ADA Curb Ramp New Construction Inspection Form (Blended Transition)

NW MAIN ST

24953

NW NORTH AVE

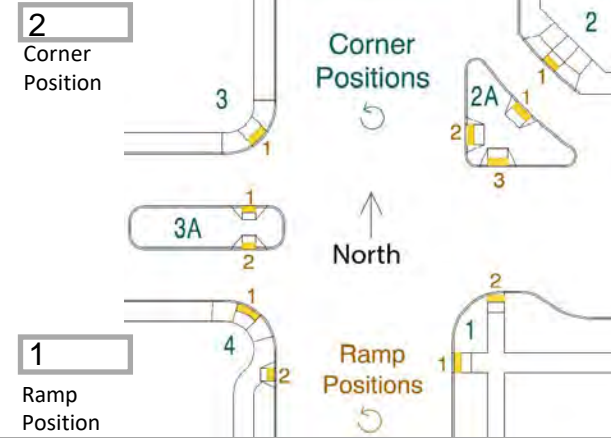
Comments:

Large crack through gutter and curb
